REGENCY MEADOW SUBDIVISION : 238 RESIDENTIAL LOTS, 49.53 ACRES

PRELIMINARY OVERALL AREA
DEVELOPMENT PLAN #351
for
REGENCY MEADOW SUBDIVISION

RE: Regency Meadows, POADP #351

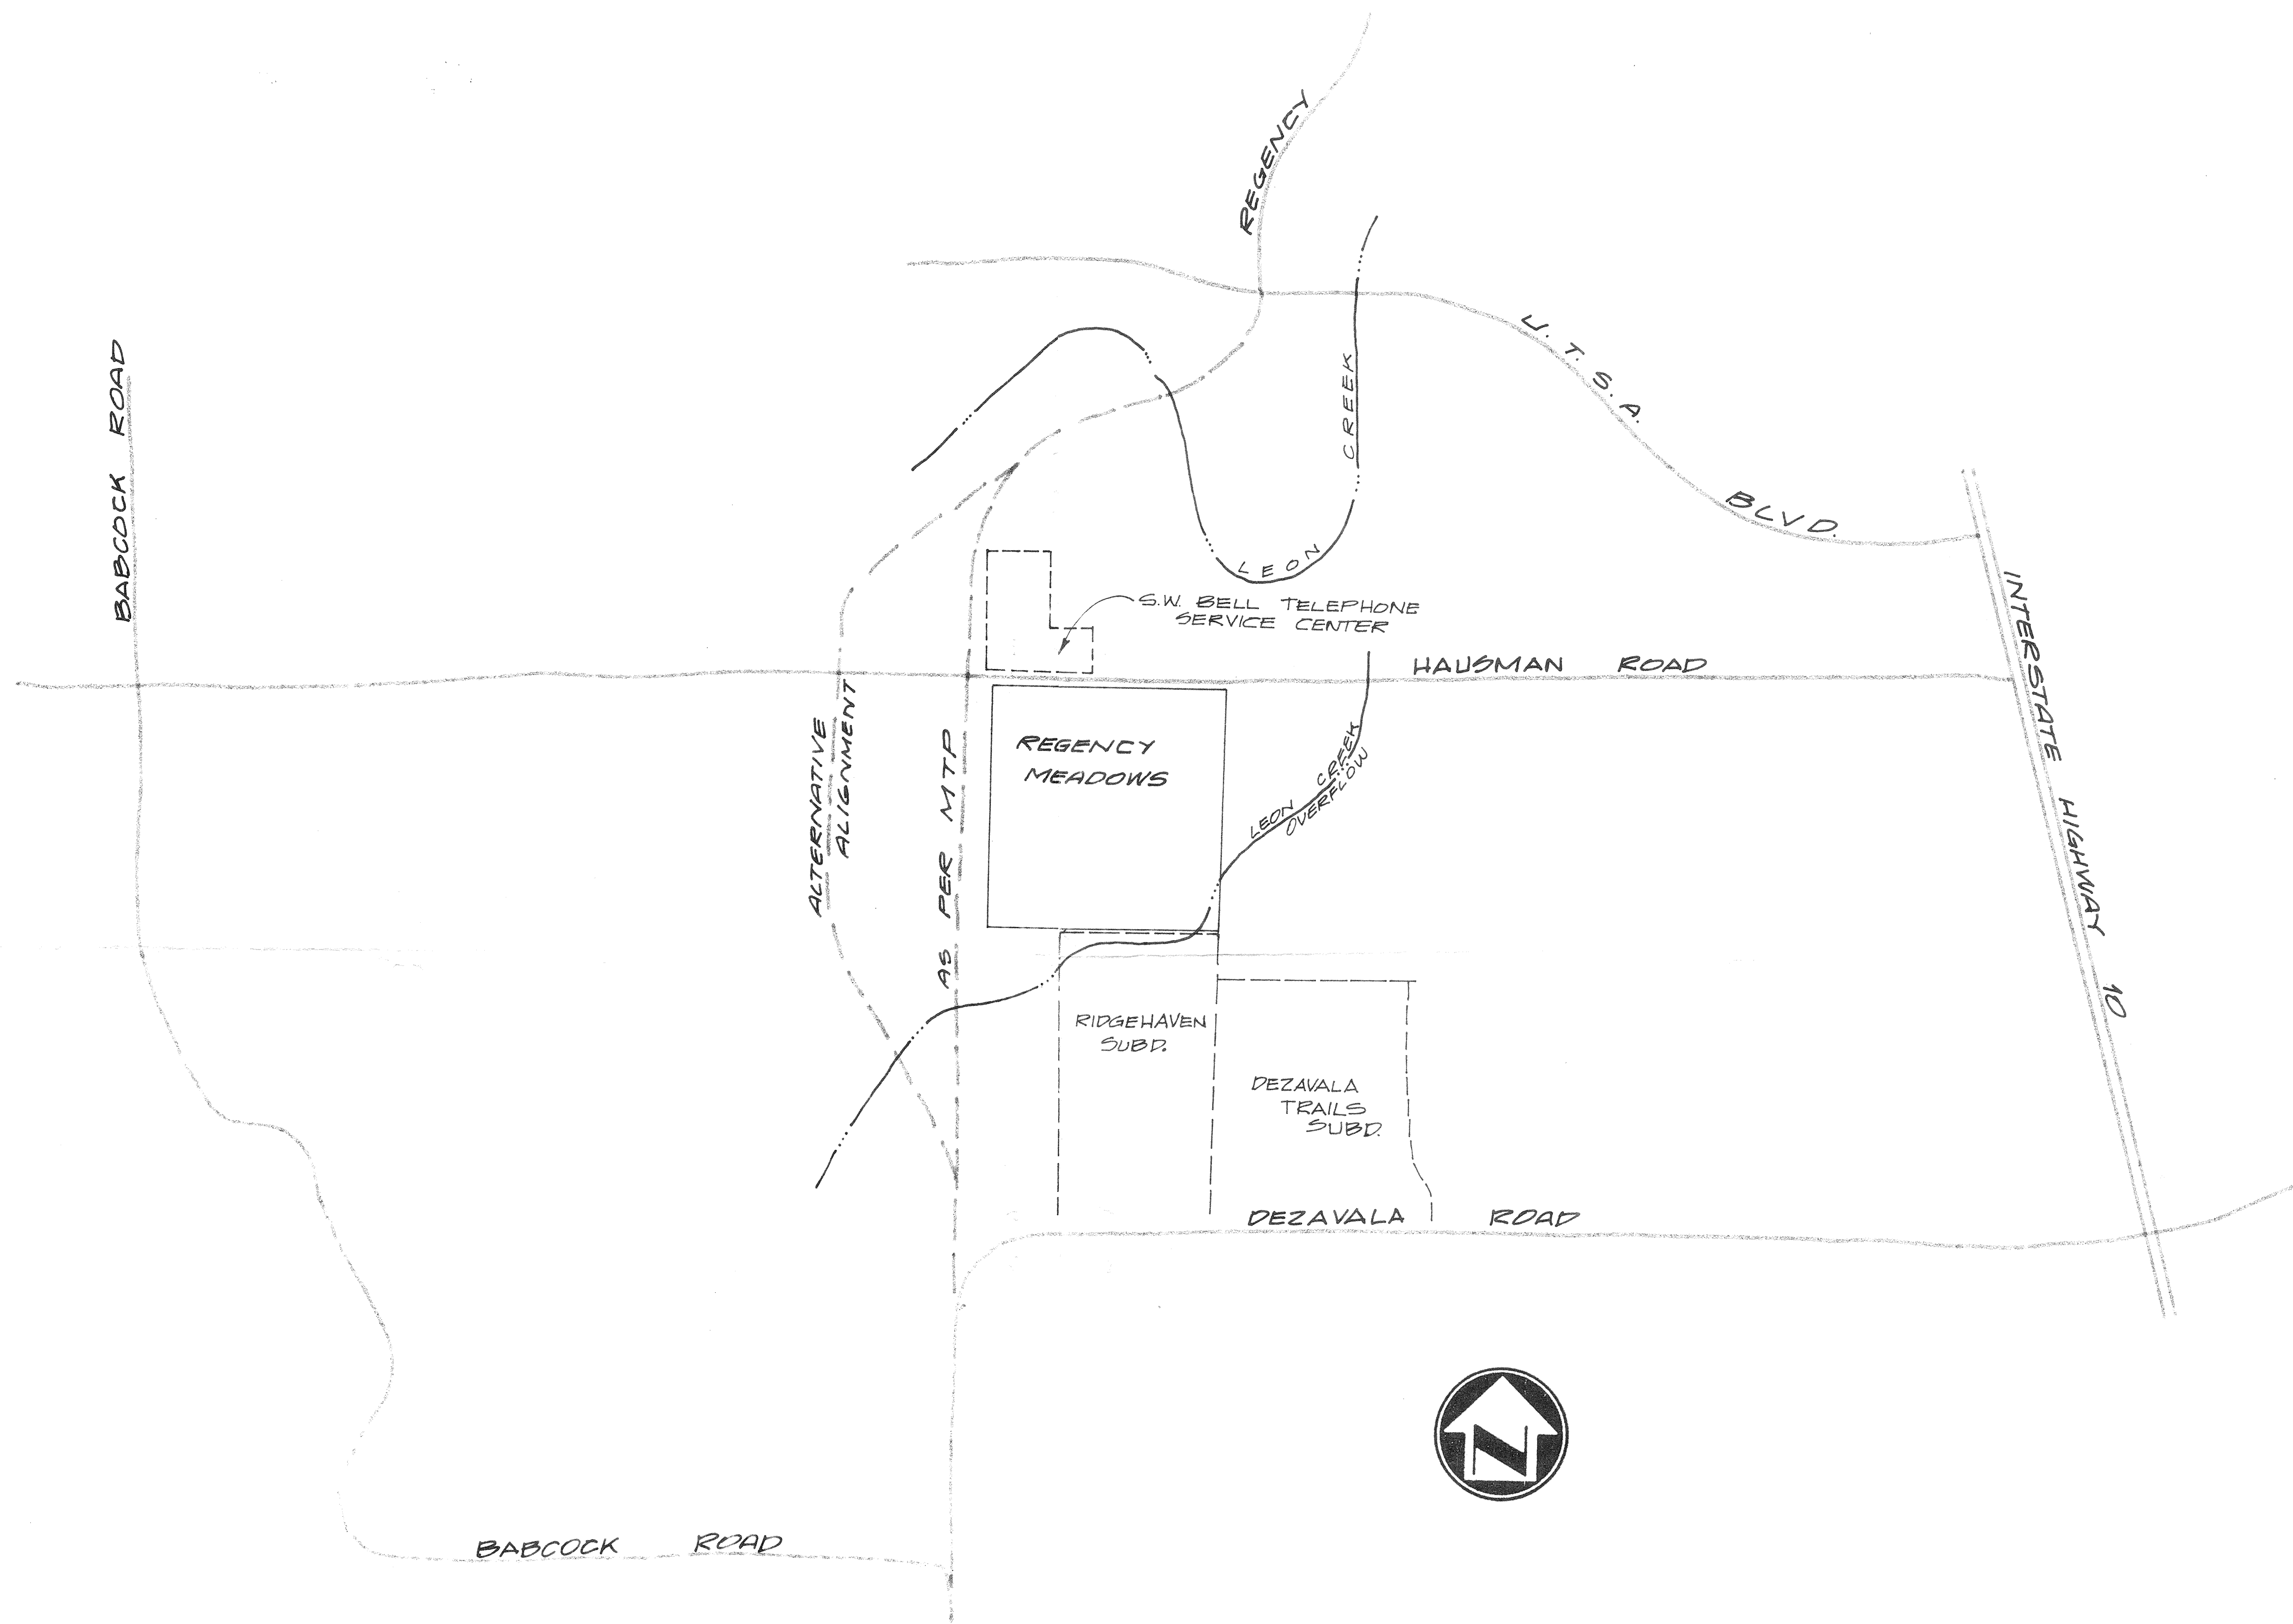
Staff has reviewed your recommended street alignment, but its consensus is to maintain a northerly extension from De Zavala, then turning in a northeasterly direction approximately north of the creek and diagonally crossing Regency Meadows property, then north to Regency Road. This alignment is the most feasible and suitable location from a cost and topography stand point. It crosses the Leon Creek at two locations and is the least expensive and shortest flood plain crossing available. Additionally, it does not conflict with a proposed United States Automobile Association irrigation reservoir planned to be located southwest of Regency and UTSA Blvd. Another consideration is that unlike, the existing Babcock Road the proposed arterial provides for a larger section to be located outside the flood plain.

City staff is currently looking at other possible alternatives for the Babcock Road alignment. However, pending other alternatives, it will be necessary to amend the Preliminary Overall Area Development Plan to reflect the alignment recommended by the staff.

The City Staff Development Review Committee has reviewed your revised Regency Meadow Subdivision Preliminary Overall Area Development Plan #351. However, your plan was not accepted after extensive review and comment by Major Thoroughfare Planning section and Traffic Engineering section representatives. It has been determined that a major arterial needs to be aligned through your property in accordance with the most current San Antonio Major Thoroughfare Plan in order for the POADP to be accepted.

The City Staff Development Review Committee has reviewed your Regency Meadow Subdivision Preliminary Overall Area Development Plan #351. However, this plan was not accepted for the following reason:

1. Your plan has three (3) unidentified strips of land along the southern perimeter in between lots. These need to be labeled appropriately.
2. Adjacent to the southern perimeter, you have indicated the property to be "Ridgehaven Subdivision". You need to delineate the existing subdivision configuration that abuts your property.
3. Additionally, you will be required to place a non-access easement along the rear of the lots along Hausman Road at the time of platting.
4. It also appears that your unit/phase boundary is extending beyond your intended limit on the southwest corner of phase "A".

Mr. Joe Nix has requested that the Commission render a final decision on the Regency Meadow Subdivision Preliminary Overall Area Development Plan #351. This plan was submitted for review and consideration by the City Staff Development Review Committee. The Committee did not accept the plan as submitted because it did not provide for a major thoroughfare through the subject property as required by the San Antonio Major Thoroughfare Plan.

City staff has reviewed and reconsidered the original plan as submitted and feels that consistent with the San Antonio Major Thoroughfare Plan, a major thoroughfare through the subject property is warranted and necessary. However, the Land Development Services Committee is considering an amendment to the San Antonio Major Thoroughfare Plan on April 12, 1993 which may resolve the issue for the applicant.

Please be advised that on April 14, 1993, the Planning Commission rendered a final decision in accordance with section 35-2073 of the Unified Development Code. The Commissions' final decision was rendered in your favor. Your original submittal for your Regency Meadow Subdivision Preliminary Overall Area Development Plan #351 without the "Babcock" extension through your property was accepted by the Commission. You may now submit individual subdivision units at your convenience.
